PCN# 20150626000

Update Temperature Sensor and LEDs,
VBAT Backup, and USB Clock Margin on:

MitySOM-5CSx Family System on Modules
5CSX-H6-42A-RC & 5CSX-H6-42A-RI

Title: MitySOM-5CSx Module Update Release

Figure 1: Previous LED Arrangement

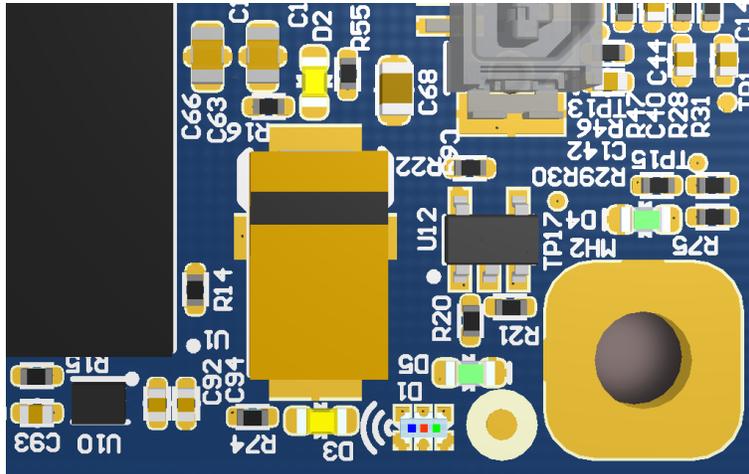
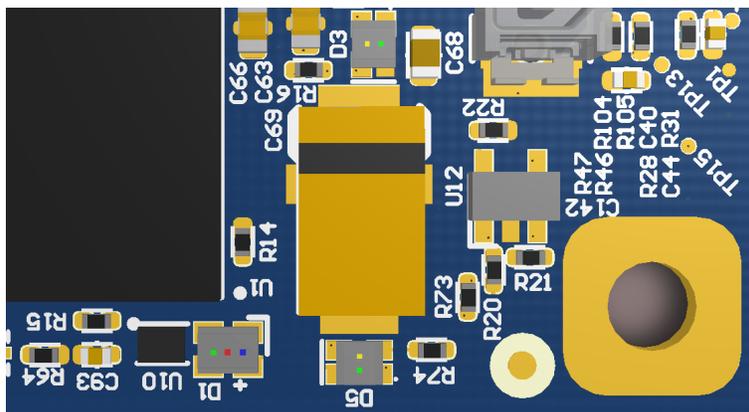
The original discrete LEDs used in the MitySOM-5CSX have been replaced with dual LED packages. With the update, D5 includes the green LED driven by the LP5562 PWM LED Driver and the yellow TRACE Debug LED. Also, D3 includes the green Power LED and the Yellow Unconfigured indicator. Previously, the green LED D4 indicated power and D2 was the green LED connected to the LP5562 LED driver.

Figure 2 LED	Combined LED Feature
D1-RGB	Software Controlled Debug RGB LED
D3-Green	Power ON
D3-Yellow	Unconfigured
D5-Green	Software Controlled Debug Green LED
D5-Yellow	TRACE MUXed
